**DPIE REQUEST FOR ADVICE – HUNTLEE STAGE 2 – SSD-70748466**

I refer to your request via the NSW Major Projects Planning Portal for advice from Singleton Council on the Environmental Impact Statement and accompanying information for Huntlee Stage 2 - SSD-70748466. Council notes that the due date for submissions was the 19 August 2024.

*Figure 1 - Extract from Figure 20: BAL MAP (SHEET 2) - O - Bushfire Assessment*

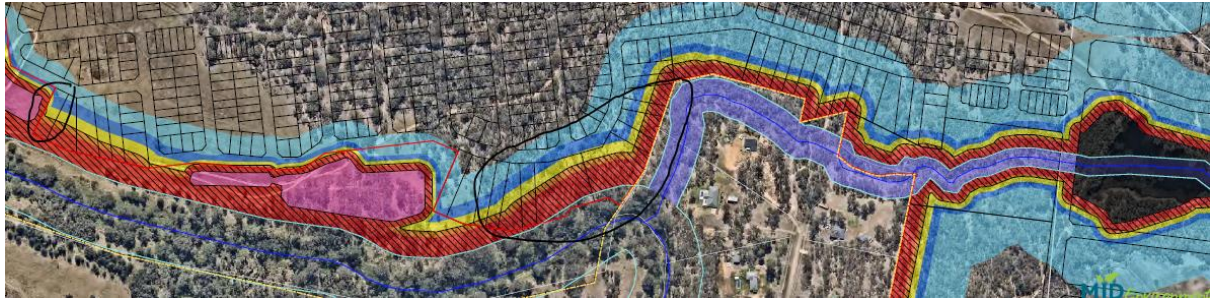
Council raises concern over the availability of a suitable building envelope to achieve a BAL-29 Construction level on the sites circled in black below:

An 88b restriction should be placed on lots that are subject to BAL-FZ and BAL-40 contours as identified on the BAL Maps contained in the Bushfire Assessment Report prepared by MJD Environmental, referenced 16015 and dated 21 June 2024, to prevent the construction of any habitable building within the BAL-FZ or BAL-40 contours. The easement is to ensure the lots accommodate the required asset protection zones (APZs) and that any future dwelling erected within the lot is located with a compliant APZ (i.e. maximum BAL-29 separation to hazard). The name of authority empowered to release, vary or modify any instrument shall be Singleton Council where the lot is located within the Singleton LGA.
